JUSTIFICATION
DRIVEWAY GATES

JUSTIFICATION
LANDSCAPING

Conservation Officer’s comments on the original scheme, received on the 25th of January 2023
Comments on the above planning and listed building consent applications.
The application site, Marlow House, is a Grade II listed building dating, from the list description, from the 15th century and located within the Lindfield Conservation Area. To either side of the building are other listed buildings- Everydens to the north is listed Grade II and dates from the 17th century, and Limes Cottage to the south, also Grade II listed, dates from the 16th century. Marlow House would be considered to be within the settings of these buildings.
Towards the rear (western) end of the garden of Marlow House, a three bay garage structure has been commenced but not completed. Planning permission for an oak framed detached garage was granted in 2014. This structure is shown as having timber cladding and a hipped clay tiled roof, but only the base of the walls appears to have been completed.

Re: GH342, Marlow House, Lindfield – Draft response to MSDC Conservation Officer

2. Proposed driveway gates

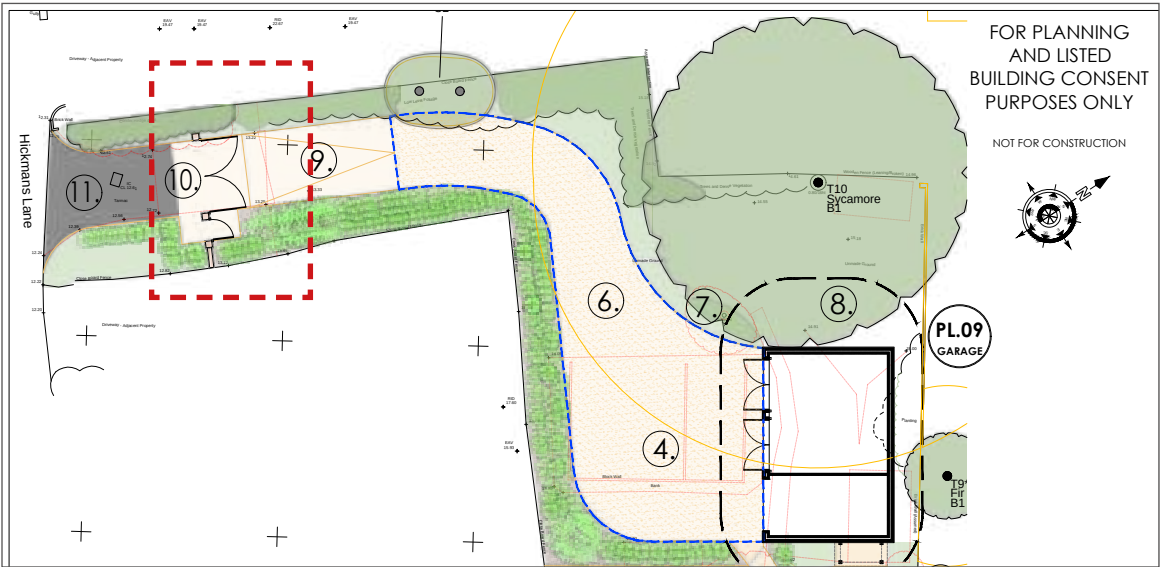
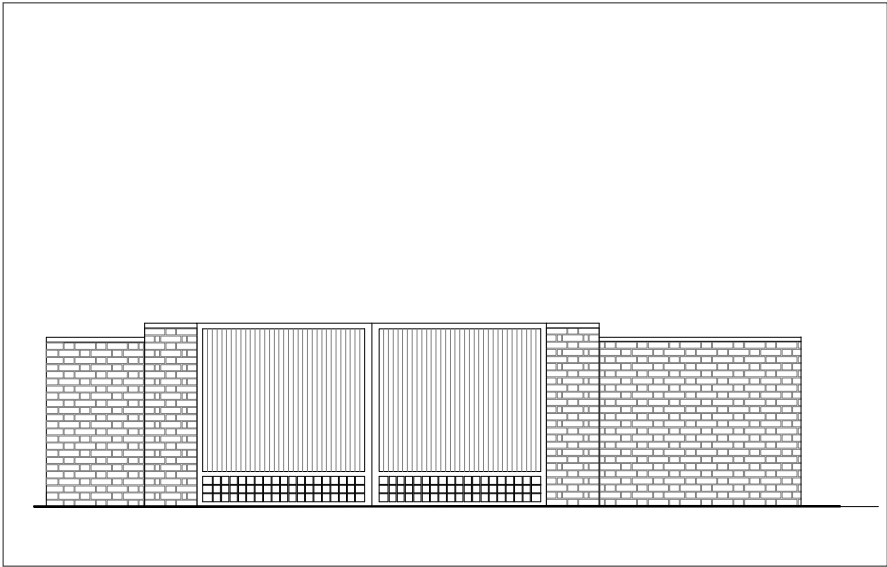
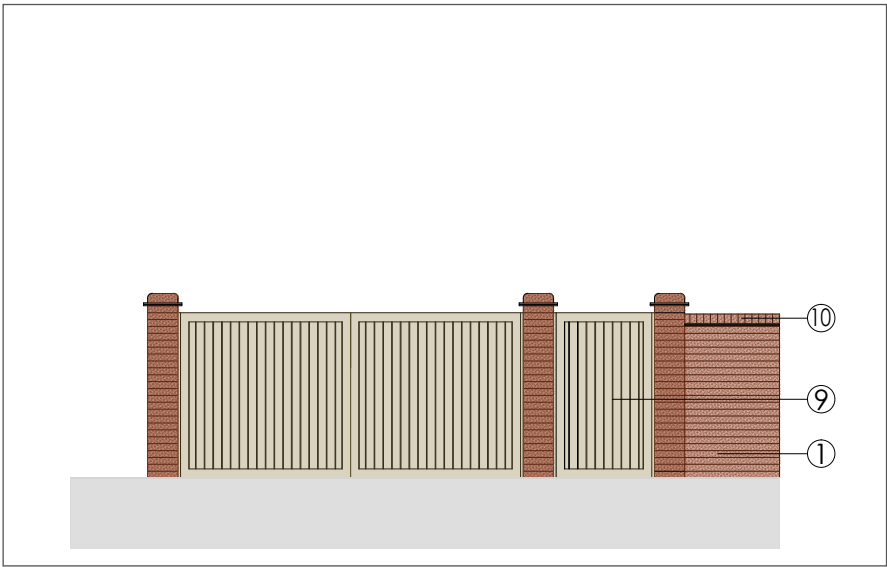
Different timber gates and brickwork piers to those in the approved scheme have been constructed, and are a deviation from the approved scheme. They are however of a modest design in keeping with the vernacular of the proposed detached garage building, and sympathetic to their Listed Building and wider Conservation Area setting, as outlined in the supporting HCUK heritage statement.

There is a lack of local planning guidance on vehicular gates and the high-quality materials and style are befitting of their setting, particularly as they are set back from the highway and flanked by vegetation that forms a visual break in Hickmans lane. Ultimately, they are metal gates with timber infill panels, a modern interpretation of traditional applications of these materials. As noted, the contemporary nature of these gates in the context of the approved contemporary extension and garage, both constructed using the same material palette, provides visual consistency across the site, underpinning the established discourse throughout the scheme of modern additions juxtaposed with the tactile characteristics of historic fabric, that has been painstakingly and sympathetically restored by expert craftsman.

2. Proposed hard landscaping

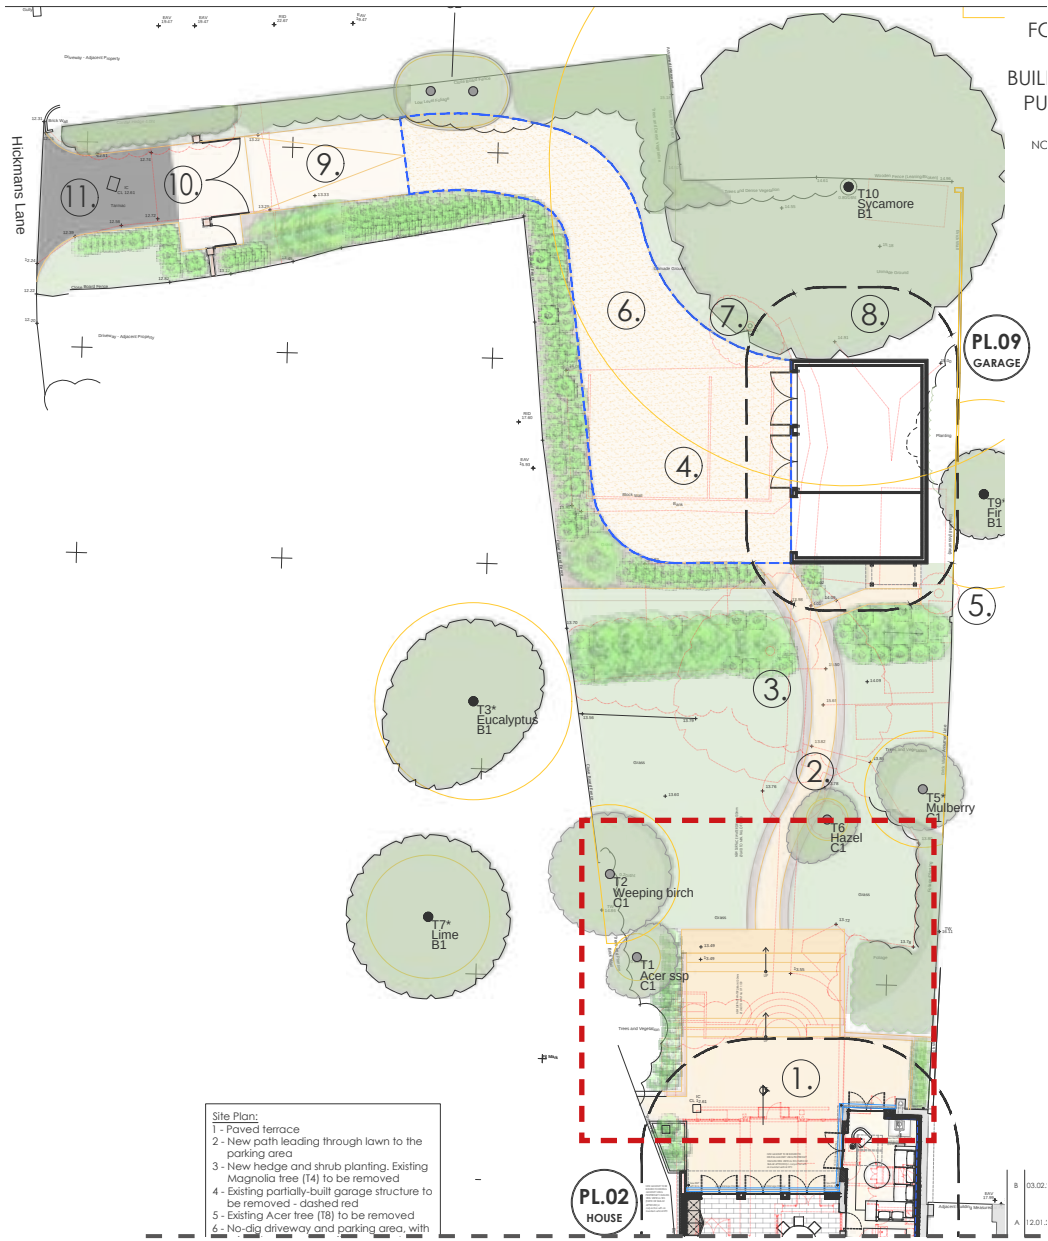
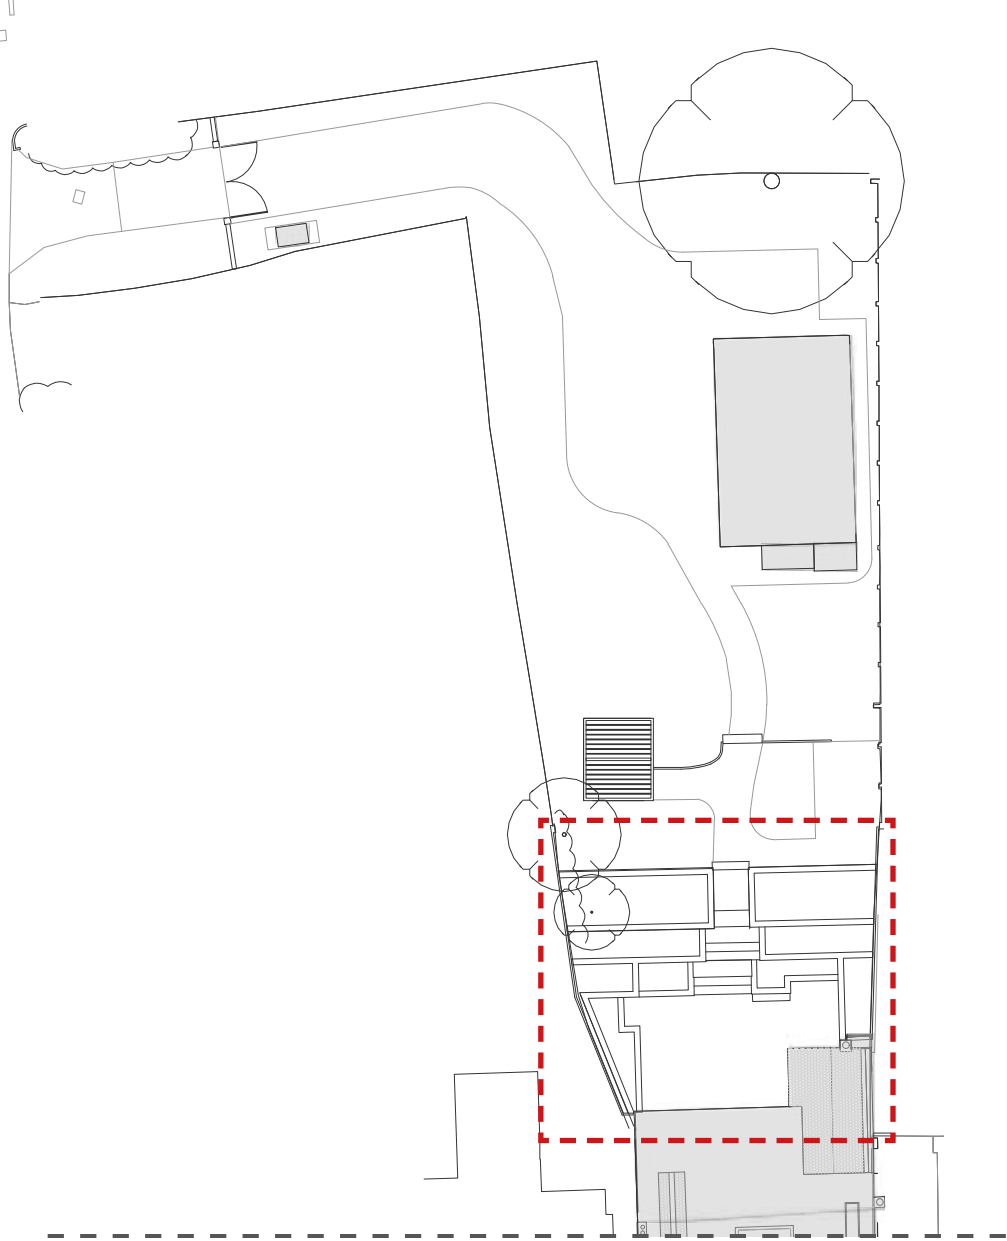
The hard and soft landscaping to the rear garden deviates from the approved scheme. However, it still enhances the setting of the building and protect the character and integrity of the Conservation Area, as outlined in the supporting HCUK heritage statement.

Refer to supplemented drawing D8 Rev B by Rachel Goozee Garden & Planting Design for further details on current hard and soft landscape design.
